JOINT REGIONAL PLANNING PANEL (Sydney East Region)

JRPP No	2013SYE099
DA Number	MOD2013/0173
Local Government Area	City of Ryde
Proposed Development	Section 96 (2) application to an approved mixed use development comprising residential and retail uses and a maximum of 4 buildings, nominated as A, B, C and D.
Street Address	125 -135 Church Street, Meadowbank
Applicant/Owner	Karimbla Constructions Services (NSW) Pty Ltd
Number of Submissions	Six (6) submissions received
Recommendation	Approval
Report by	Michael Tully - Town Planner

Assessment Report and Recommendation

Figure 4. Section 96 plaza area demonstrating the location of the outdoor play area for the child care centre, the re-adjusted stairs and landscaped area

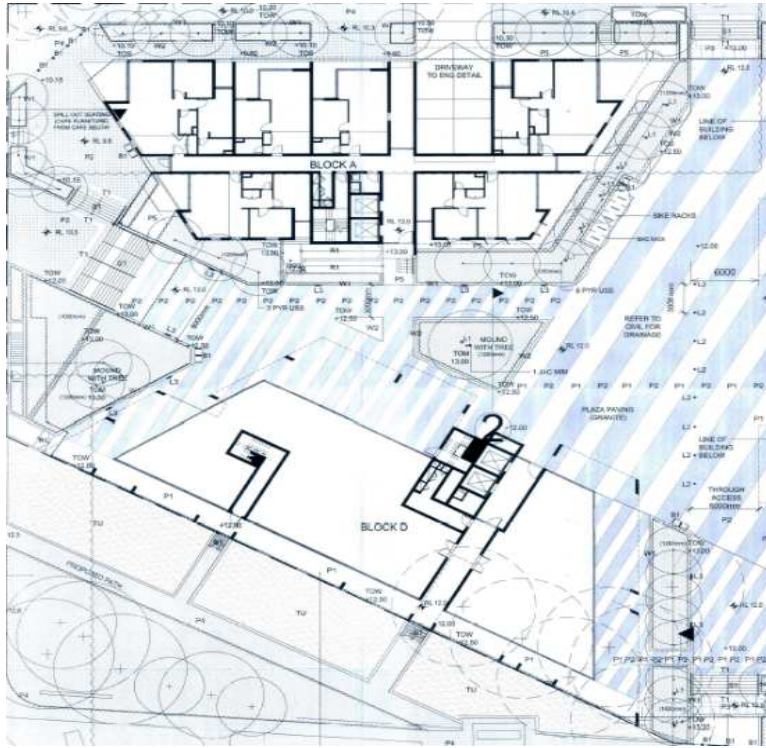
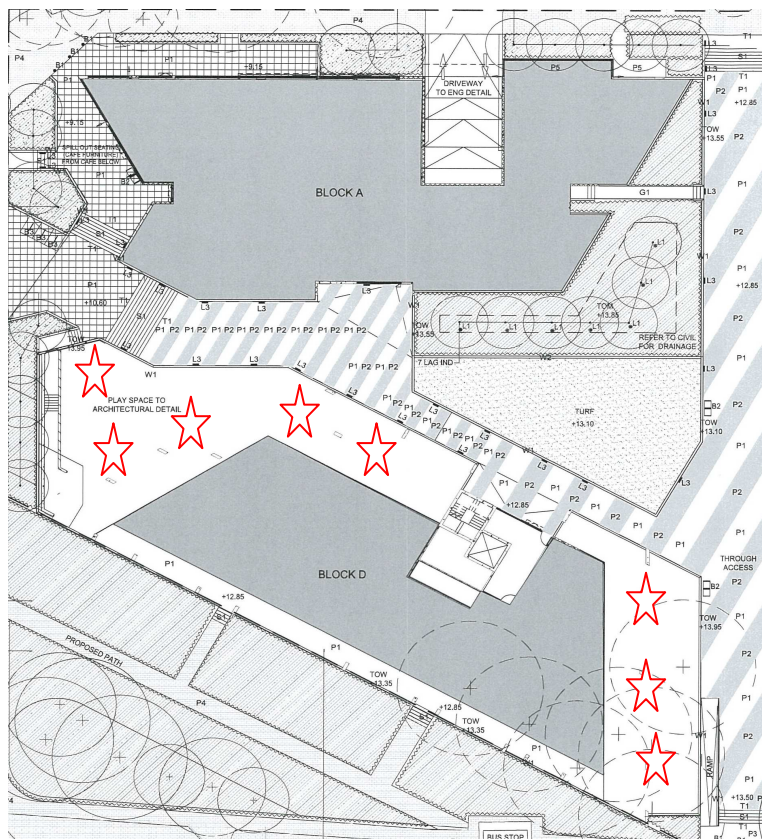
- *the proposed 1200mm high fencing of the playground on the eastern side of the child care centre should be located above the child care side of the planter rather than along the side that is immediately adjacent to the access way.*

2. *The proposed direct ramp from Church Street to the access way in lieu of the switch back ramp is supported.*
3. *Whilst the conversion of the ground floor retail in Building D to a child care centre can be supported, the proposed extent of the outdoor play area compromises the function and character of the plaza and the development's presentation to Well Street. The plaza level and Well Street frontage is to be redesigned and a revised Landscape Plan and Sections provided so that:*
 - *The width of the stairs from Well Street to the plaza is to be no less than the steps in the approved DA.*

- *The lower level planting area adjacent to the fire escape on Well Street is to be retained.*

- *Circulation within the plaza is to be as per the approved DA including the provision of an area that is suitable for the planting of tree (s) that will attain a min size of 8 metres. It is noted that to achieve a satisfactory layout, the size of the outdoor play area will need to be reduced and this may reduce the number of children that can be accommodated within the child care centre.*

Comment: The applicant provided amended plans which incorporated a 1.8m high multi-coloured glass panel fence surrounding the outdoor play areas of the child care centre. The applicant deleted the planter boxes from within the outdoor play areas and relocated them adjacent to the outside wall of the courtyards associated with the dual use home/office units. This will allow for adequate surveillance as well as increasing the perceived width of the walkway through the plaza.

Comment: The applicant initially increased the width of the stairs to 7m from 6m (original approval was 8m). However, in order to accommodate a 2.5m easement within the Well Street frontage, the area of the outdoor play space was reduced and subsequently the plaza width was returned to 6m to maintain the minimum outdoor space requirements for a child care centre. This results in the width being 2m less than what was approved in the original application. While this is an undesirable situation, the 6m width can be supported. There are no controls in the DCP which specifies any requirement for public access and the public access between Church Street and Porter Street is also 6m wide.

Comment: A 2.5m wide strip of deep soil planting is provided within the Well Street frontage in front of the outdoor play space associated with the child care centre. While this is not as large as the approved planting area, it is deemed adequate as it provides an inviting landscaped area at the entrance to the plaza.

Comment: The circulation space within the plaza will be reduced as part of the section 96. This is considered to be an adverse consequence of the Section 96, however as detailed above, it can be supported. A benefit of the Section 96 is the reduction in paved area and increased amount of green space. The size of the outdoor play area for the child care centre has been reduced from an area to accommodate 90 children to an area that will accommodate 84 children.
